SEWAGE DISPOSAL SYSTEM

MARYLAND STATE DEPARTMENT OF HEALTH

ADDRESS 12161 Mount Albert Court, Ellicott City, MD 21043 PHONE 531-2080

RE: Repair Percolation
10140 Washington Boulevard

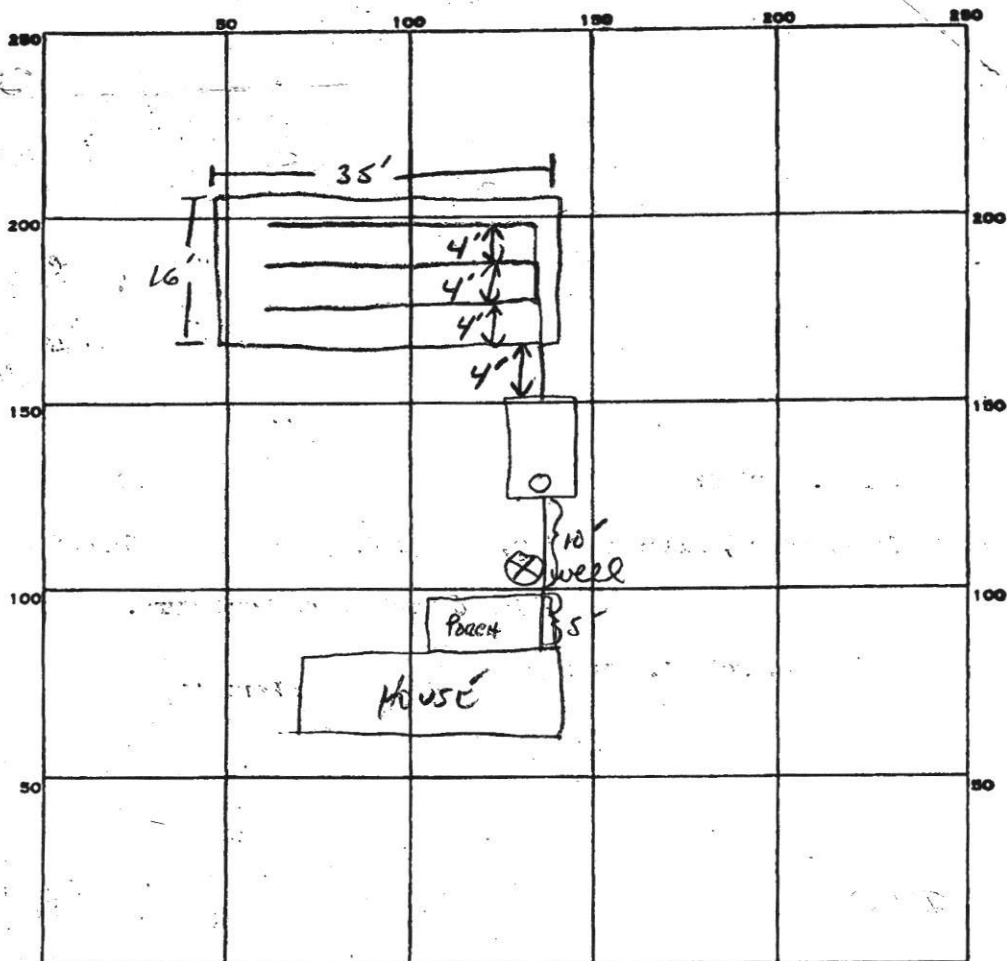
RECOMMENDATION: LEACHING BED, BOTTOM MAXIMUM DEPTH 4.0 FT, INLET AT 2-5 FT, 18 INCHES OF STONE BELOW PIPE. MAKE LEACHING BED 20 FT X 25 FT AS SEEN WHEN FACING FROM US1. BEGIN BED 20 FT FROM BACK OF HOUSE AND 10 FT LEFT OF CORNER OF HOUSE. RUN TRENCH ON LEVEL GROUND TOWARD RIGHT OF HOUSE AS SEEN WHEN FACING LOT FROM US1. MUST ABANDON PRESENT WELL IN BACK OF HOUSE, AND CONNECT TO COMMUNITY WATER. OWNER STATES "PLANS TO CONNECT TO CITY WATER." SABel

REMARKS 10 AM 4-11-85 OK TO CONTINUE WORK, Fill well with 5-7' Fill Soil, 3' Cement AND 2' Fill soil. - Well 12' deep with 3-4' water. Fixture removed from House. Sable

4-11-85 1145 AM OK TO CORK BED AND TANK; 7' Fill to well \pm 3' CEMENT PLUG + 2' Fill on top. Sable

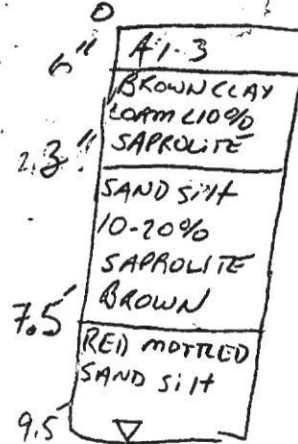
1 S 2' 10:09 10:45 100 SLOW 1/4" remaining 1st inch

1 M 4.5' 10:09 10:10 10:10 10:11 - 1 min

1 V 10.5' WATER AT 9.5'

2- WATER AT 7' CLAY TO 7'

3- WATER AT 5.5'
